## Addendum

Date: April 4, 2025

Project: 24.1095 MCSC Lobby & General Improvements City of Kenora

**No.1**

LIGHTING, POWER & SYSTEM PLAN – LOBBY AND MULTIPURPOSE ROOM

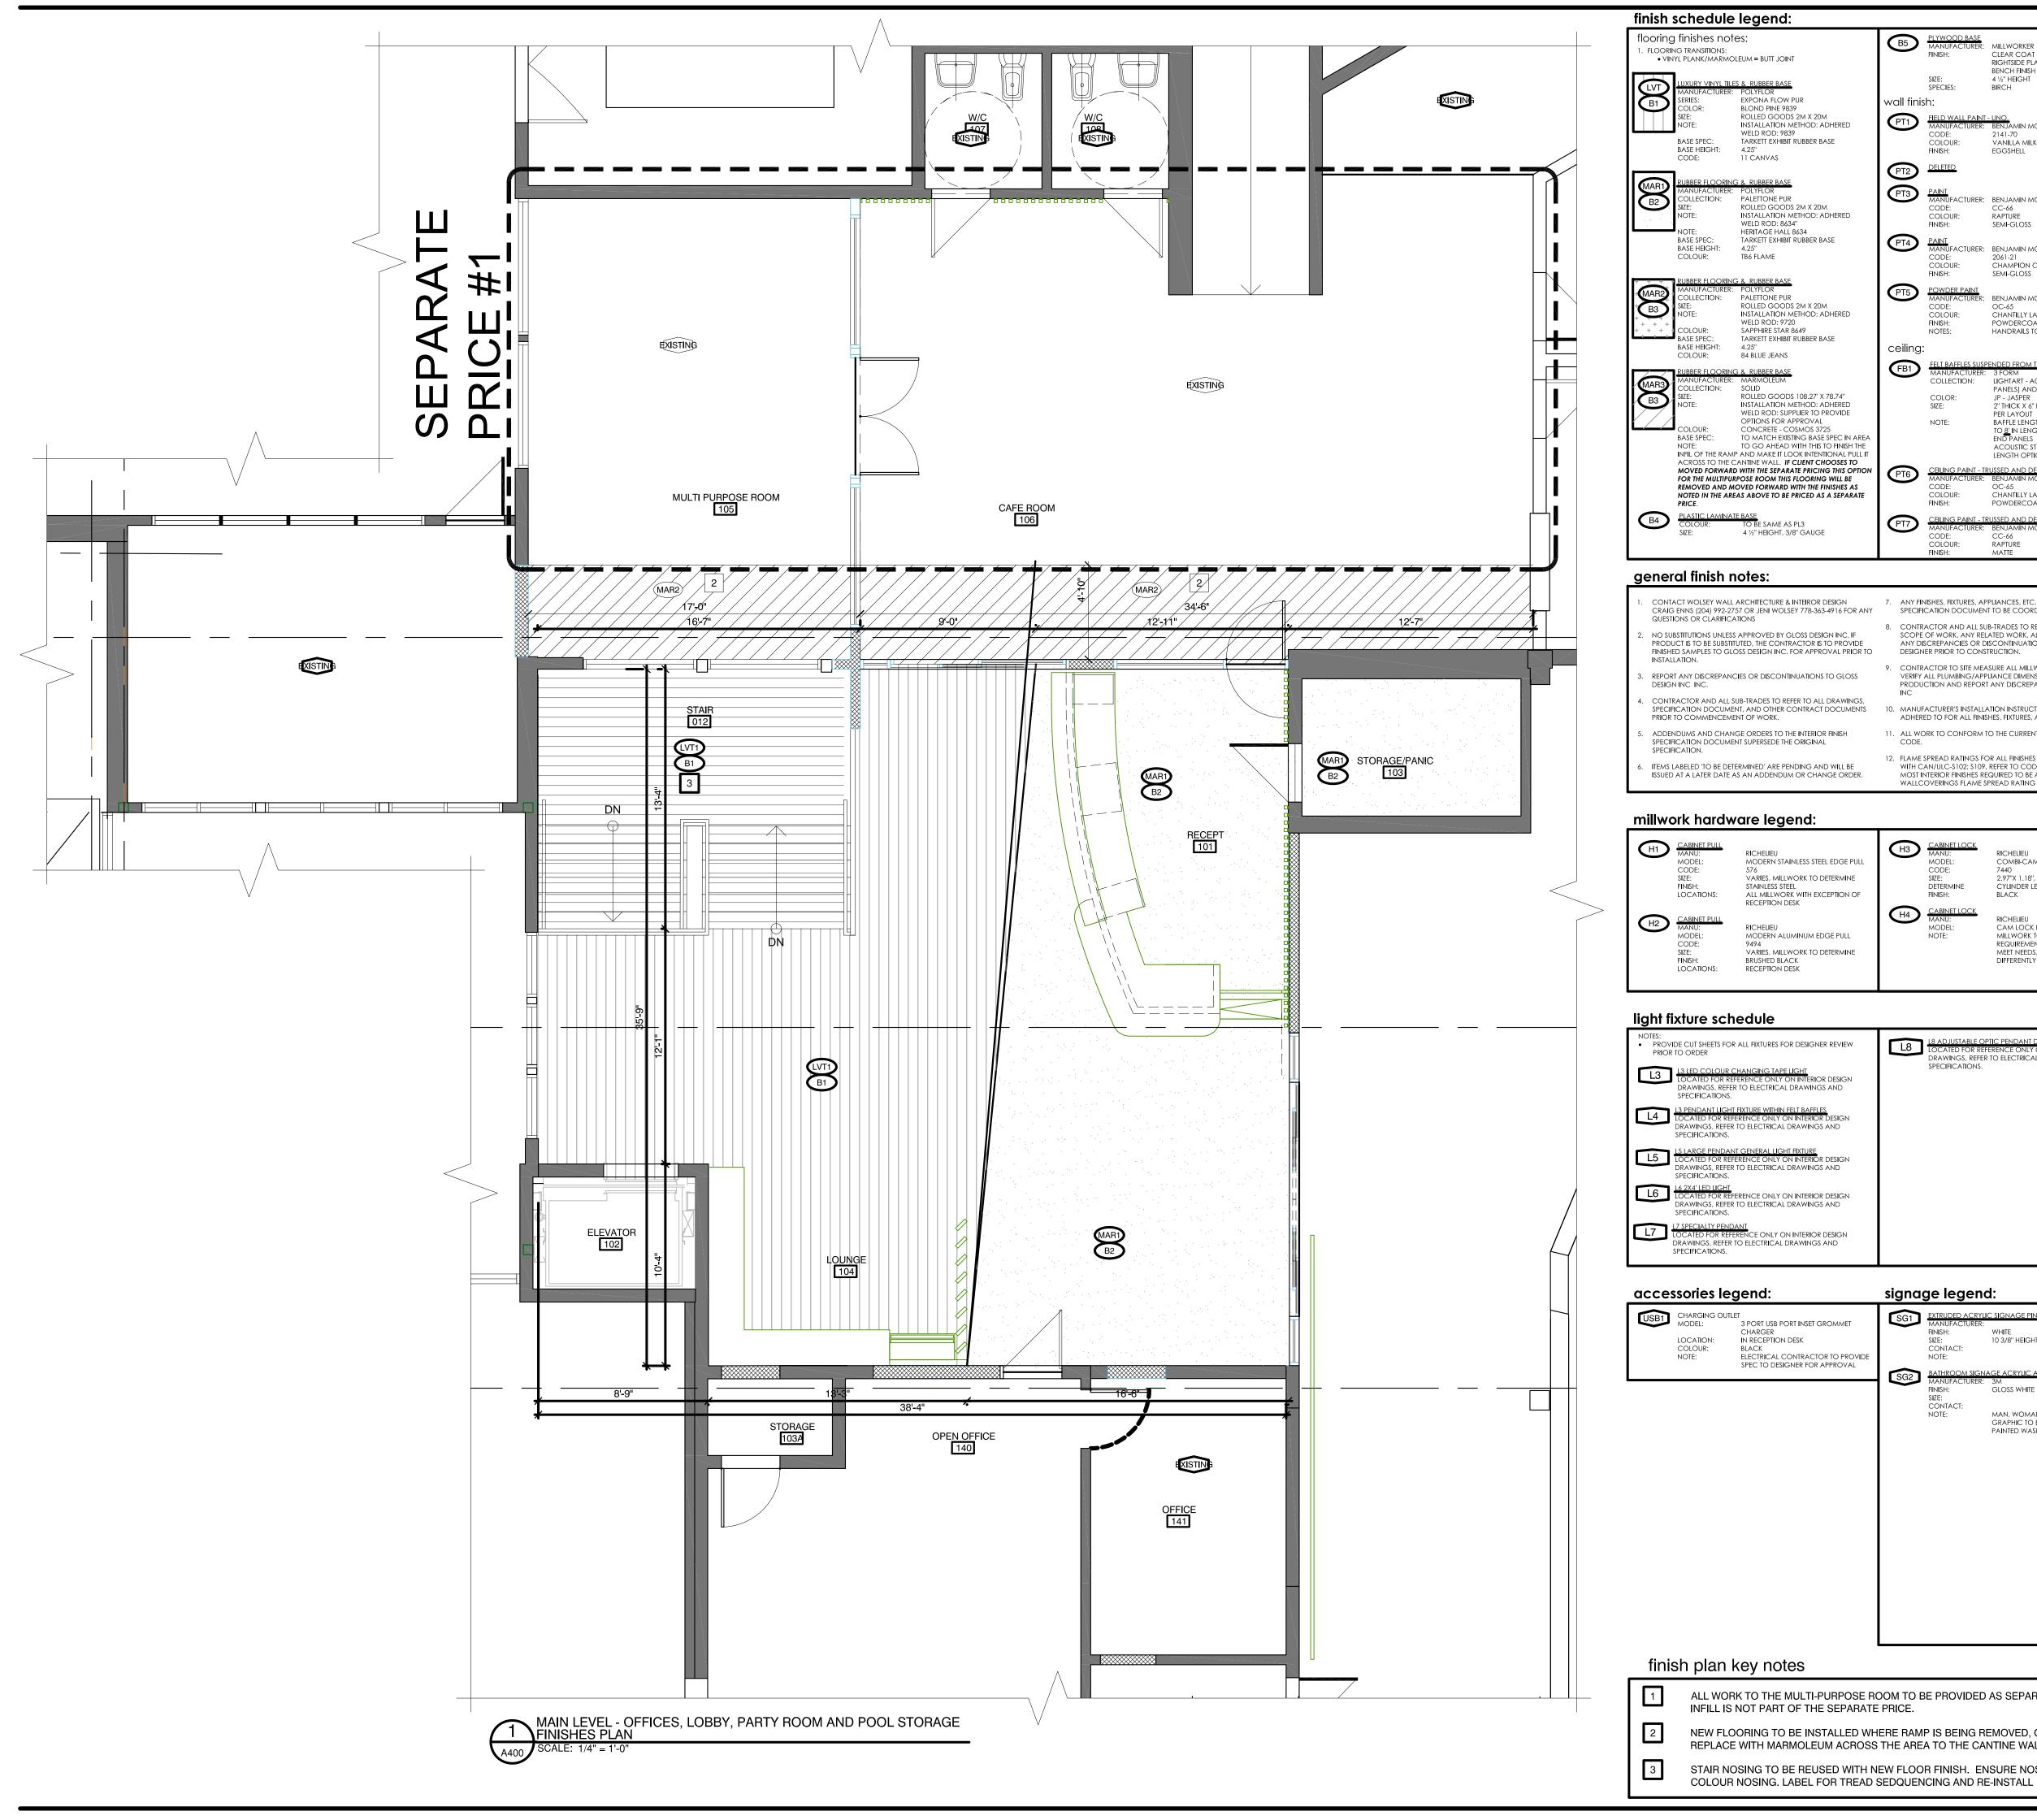
Refer to the attached Electrical Addendum **231549 E Addendum 01** and associated Drawing **E3.1R1**, with changes summarized below:

1. Remove strip lighting on existing lobby stairs

- 1.1 Refer to Drawing E2.1 Demolition Plan Lobby and Multipurpose Room dated March 25, 2025.
  - .1 Revise 1/E2.1 title to "MAIN LEVEL LOBBY AND MULTIPURPOSE ROOM".
- 1.2 Refer to Drawing E3.1 Lighting, Power and System Plan Lobby and Multipurpose Room dated March 25, 2025.
  - .1 Refer to 1/E3.1 Main Level Offices, Lobby, Party Room and Pool Storage: Revise main level plan and 1/E3.1 title as shown on attached full sized drawing E3.1R1.

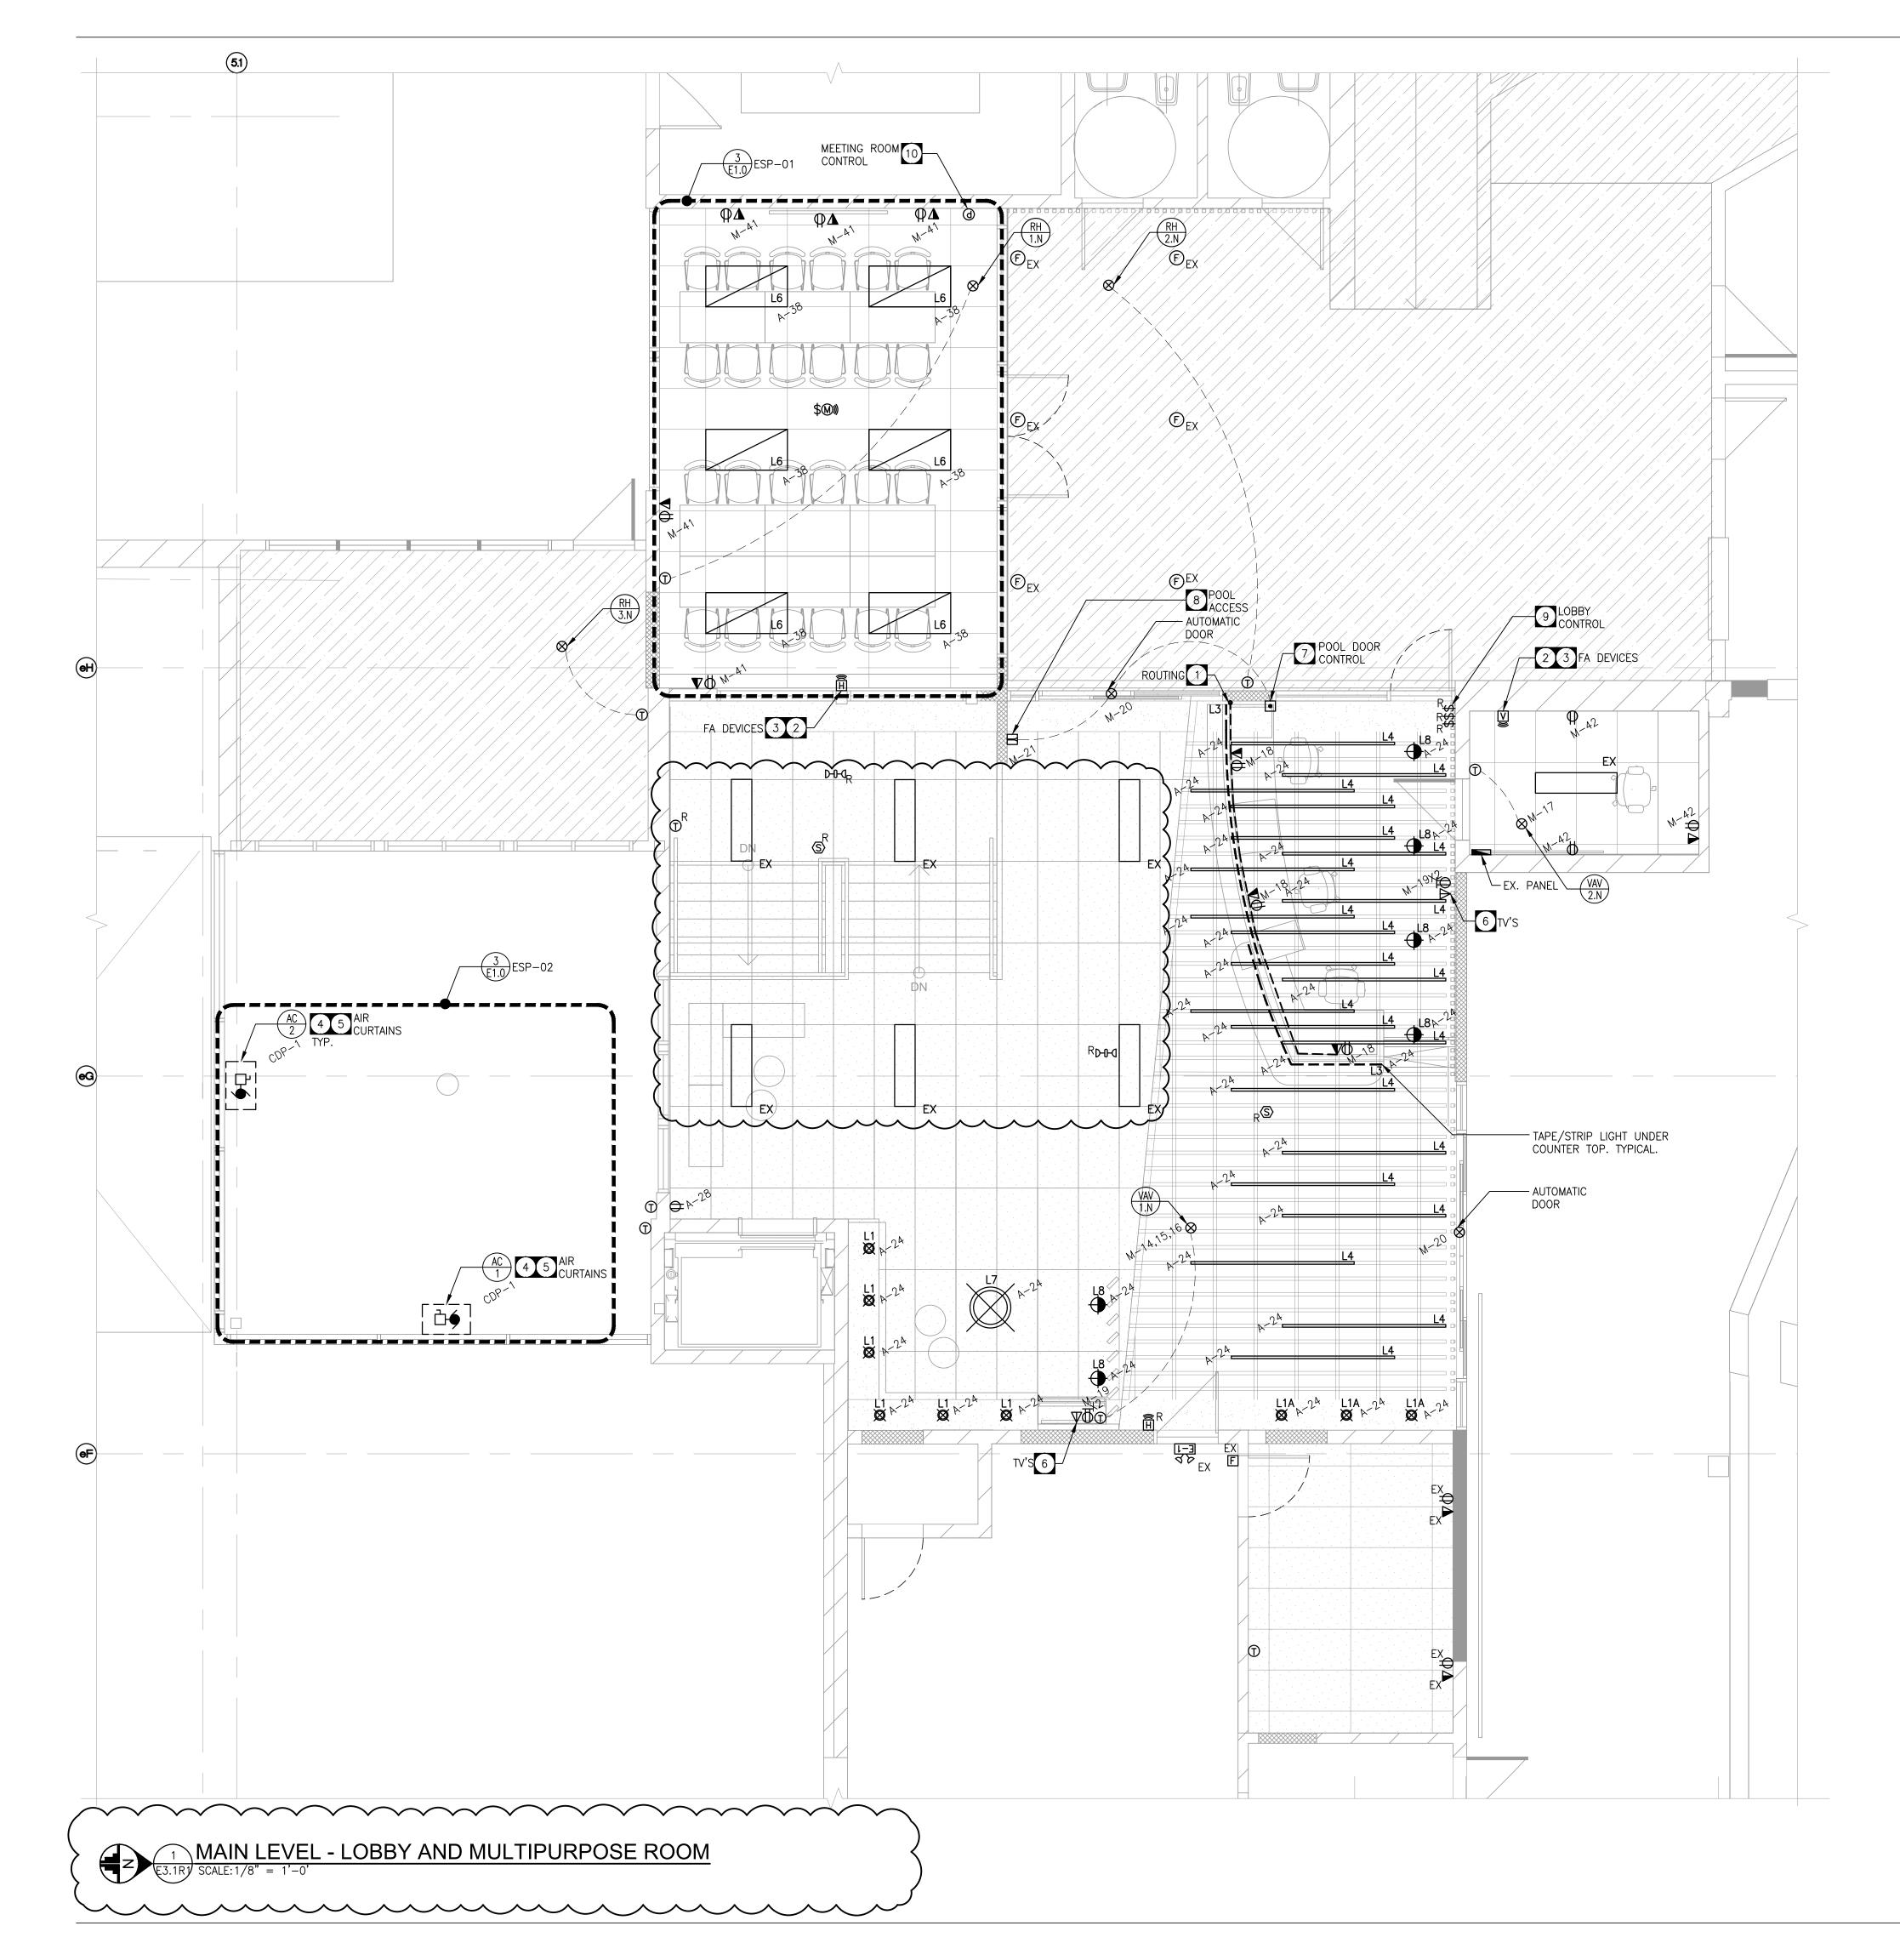
Refer to attached drawings **21.1095 – A400r1**, Dated March 25, 2025, with changes summarized below:

1. Remove general finish notes 13 and 14
